Addendum 47: Regulation No. 48

Revision 9 – Amendment 2

Supplement 2 to the 06 series of amendments - Date of entry into force: 3 November 2013

Uniform provisions concerning the approval of vehicles with regard to the installation of lighting and light-signalling devices

Figure (see paragraph 6.5.)

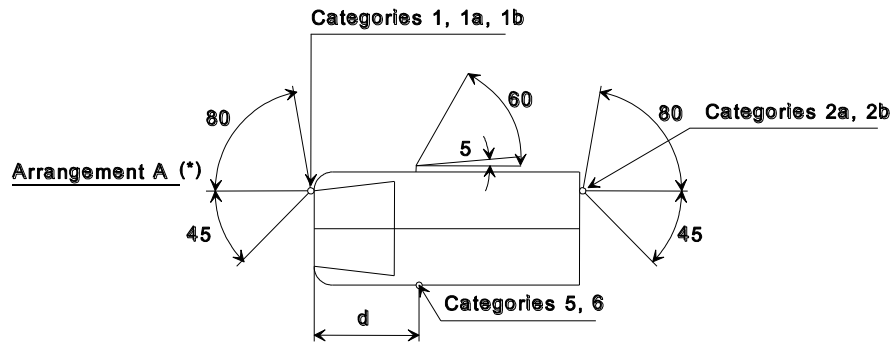
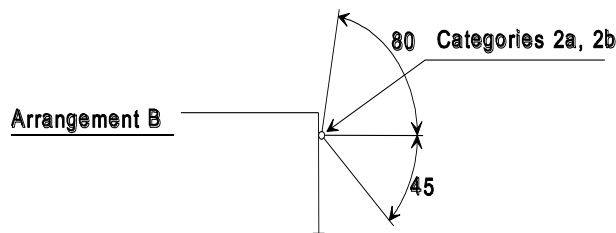
Paragraphs 6.5.5. to 6.5.5.2., including the figures, amend to read:

6.5.5.1. Horizontal angles: (see figure below)

Vertical angles: 15° above and below the horizontal for direction indicator lamps of categories 1, 1a, 1b, 2a, 2b and 5.

- (a) Where a lamp is mounted below 750 mm (measured according to the provisions of paragraph 5.8.1), the downward angle of 15° may be reduced to 5° ;
- (b) Where an optional rear lamp is mounted above 2,100 mm (measured according to the provisions of paragraph 5.8.1. above) the upward angle of 15° may be reduced to 5° .

30° above and 5° below the horizontal for direction indicator lamps of category 6.

(*) The value of 5° given for dead angle of visibility to the rear of the side direction-indicator is an upper limit $d \leq 1.80$ m (for M_1 and N_1 category vehicles $d \leq 2.50$ m).

For the direction indicator lamps of categories 1, 1a, 1b, 2a and 2b mounted below 750 mm (measured according to the provisions of paragraph 5.8.1), the inward angle of 45° may be reduced to 20° under the H plane.
